UNITED STATES PATENT AND TRADEMARK OFFICE

APPLICATION NO.	FILING DATE	FIRST NAMED INVENTOR	ATTORNEY DOCKET NO.	CONFIRMATION NO.	
10/567,532	06/21/2006	Karl Griesbeck	30071/41834	9362	
7500 MARSHALL, GERSTEIN & BORUN LLP 233 S. WACKER DRIVE, SUITE 6300			EXAM	EXAMINER	
			NIESZ, JASON KAROL		
SEARS TOWER CHICAGO, IL 60606		ART UNIT	PAPER NUMBER		
			4147		
			MAIL DATE	DELIVERY MODE	
			04/01/2008	PAPER

Application No. Applicant(s) 10/567.532 GRIESBECK, KARL Office Action Summary Examiner Art Unit JASON K. NIESZ 4147 -- The MAILING DATE of this communication appears on the cover sheet with the correspondence address --Period for Reply A SHORTENED STATUTORY PERIOD FOR REPLY IS SET TO EXPIRE 3 MONTH(S) OR THIRTY (30) DAYS. WHICHEVER IS LONGER, FROM THE MAILING DATE OF THIS COMMUNICATION. Extensions of time may be available under the provisions of 37 CFR 1.136(a). In no event, however, may a reply be timely filed after SIX (6) MONTHS from the mailing date of this communication. If NO period for reply is specified above, the maximum statutory period will apply and will expire SIX (6) MONTHS from the mailing date of this communication - Failure to reply within the set or extended perio

Figure 1 is Figure 1 from Dunn with labels added by the examiner.

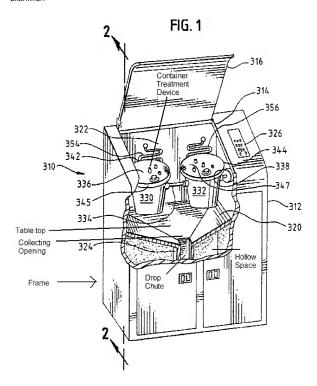
In Re claim 1 with reference to Figure 1 above Dunn discloses a container treatment machine comprising: a frame, a table top and a collecting opening wherein the areas of said table top connected to the collecting opening are inclined with a falling slope to the collecting opening.

In Re claim 2 with reference to Figure 1 above Dunn discloses a drop chute connected to the collecting opening

In Re claim 3 with reference to Figure 1 above Dunn discloses a collecting opening having a rectangular base shape and being centrally located in a table top which also has a rectangular base shape.

In Re claims 4 and 5 with reference to Figure 1 above Dunn discloses a ring shaped hollow space between the drop chute and the outside walls of the frame. Statements of intended use have been considered and determined not to limit the structure of the invention: the hollow space disclosed in the prior art could be used to receive one of drive elements, and control elements.

In Re claim 6 with reference to Figure 1 above Dunn discloses a treatment device for containers arranged above the collecting opening.
